Amendments to the Drawings:

REMARKS

The present Amendment is in response to the Examiner's Office Action mailed February 27, 2006. Claim 42 is cancelled, claims 4, 7, 8, 17, 18, 26, and 34 are amended, and no new claims have been added. Claims 1-41 and 43-46 are now pending in view of the aforementioned cancellation.

FIG. 2

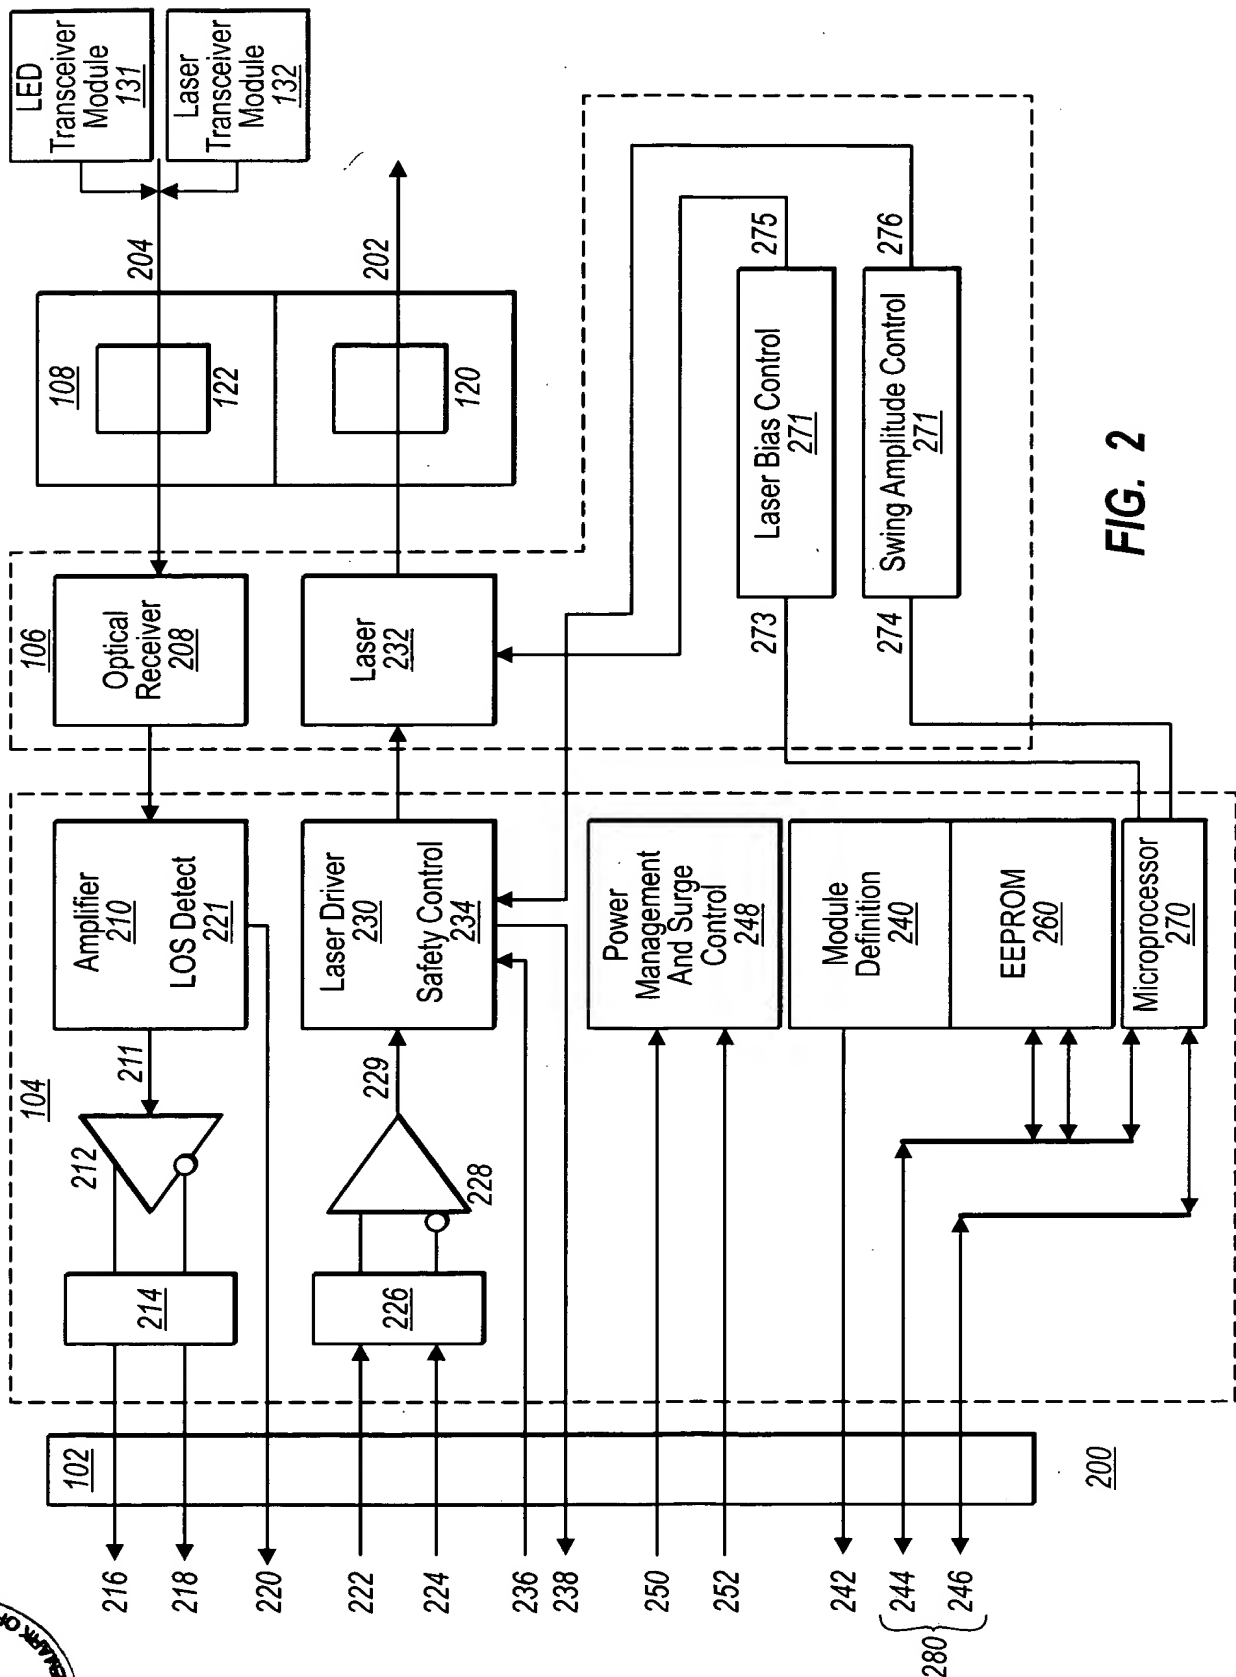
The attached sheet of drawings includes changes to Figure 2. This sheet, which includes Figure 2, replaces the original sheet including Figure 2. In Figure 2, previously omitted elements 131 and 132 have been added.

The Office Action in Section 2 objects to the drawings under 37 C.F.R. § 1.83 (a) as failing to show every feature of the claims. Specifically, the Office Action alleges that the "LED

based transmitters” of claims 1, 15, 25, 42, and 43 and the “filtering components for coupling to the optical source” of claims 4, 7, 8, 17, 18, 26, and 34 are not illustrated in the existing figures.

In response, Applicant has amended Figure 2 to include a laser based transceiver 132 and a LED based transceiver 131. These elements are supported at least by page 2, lines 21-28 and page 11, lines 20-28 of the specification. As mentioned above, Applicant has included a red lined version of Figure 2 showing the amendments to the figure. Applicant believes that no new matter has been added.
